Project Name: Vienna Town Hall Interior Renovations **W|W Comm. No.:** 210167.00
Submittal Reviewed: Issued For Construction (w/Addendum 1)
Submittal Date: 7/23/2012 (8/29/2012)
RFIs Submitted To: Gina Gilpin, Town of Vienna
Responding Entity: Wiley|Wilson

RE: BID RFI COMMENTS AND A/E RESPONSES

PROJECT	VIENNA TOWN HALL INTERIOR RENOVATIONS
TITLE	DAIS KEVLAR PANELING PLAN & ELEVATION
DRAWN ADT	CHECK REB
COMM. NO. 210167.80	
SCALE AS NOTED	
SKETCH NO.	
ASK-1	
DWG. REFERENCE NO. A402	
DATE 09/20/12	REV.

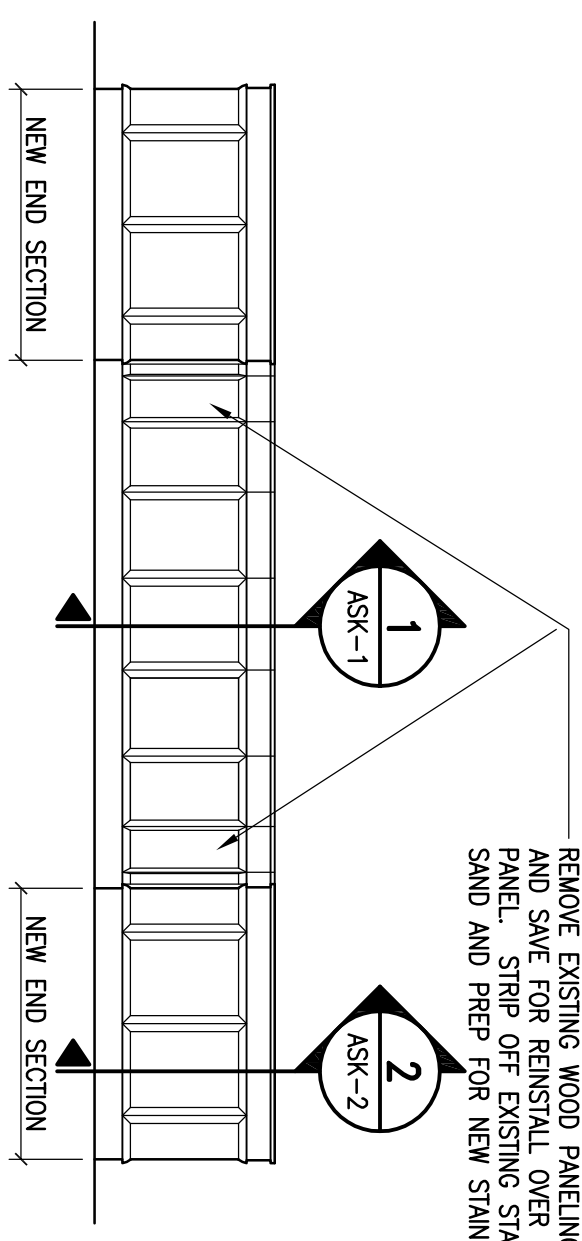
Response	Door D-B01 has an existing manual lock to remain. The contractor shall furnish and install a door magnetic contact for the door D-B01 to detect the position of the door.
3	09/20/2012	Comment	A-101 & A-402, Dais – Owner has requested Kevlar panels to be added to the Dais.

REMOVE EXISTING WOOD PANELING & TRIM AND SAVE FOR REINSTALL OVER NEW KEVLAR PANEL. STRIP OFF EXISTING STAIN AND SAND AND PREP FOR NEW STAIN.

REMOVE EXISTING WOOD PANELING & TRIM AND SAVE FOR REINSTALL OVER NEW KEVLAR PANEL. STRIP OFF EXISTING STAIN AND SAND AND PREP FOR NEW STAIN.

REMOVE EXISTING WOOD PANELING & TRIM AND SAVE FOR REINSTALL OVER NEW KEVLAR PANEL. STRIP OFF EXISTING STAIN AND SAND AND PREP FOR NEW STAIN.

Response	7/32” bullet resistant Kevlar panels (UL 752 Level 3 Protection) are to be added to all three sides of the Dais. See attached sketches ASK-1 and ASK-2 for details and notes.
4	09/20/2012	Comment	AD 101 Key Note #1 calls for repair of walls before drywall is to be installed. The amount of damage is unknown and in order that all bidders treat this condition equally, we suggest a monetary allowance be included for possible repairs.
